Service Information

REVISED

Revision NOTE: "PARTS INFORMATION" has been changed.

Subject: Wind Noise from Front Part of Front Door

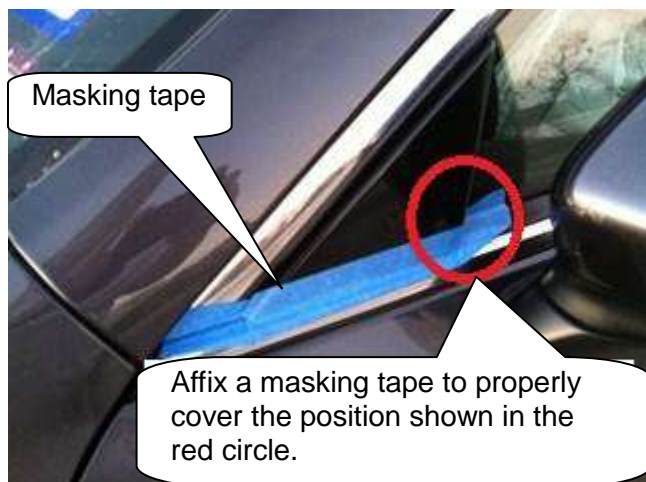
MASS PRODUCTION CHANGE

Configuration of the front beltline molding and other respective parts have been changed to narrow the gaps between the door and the body panel.
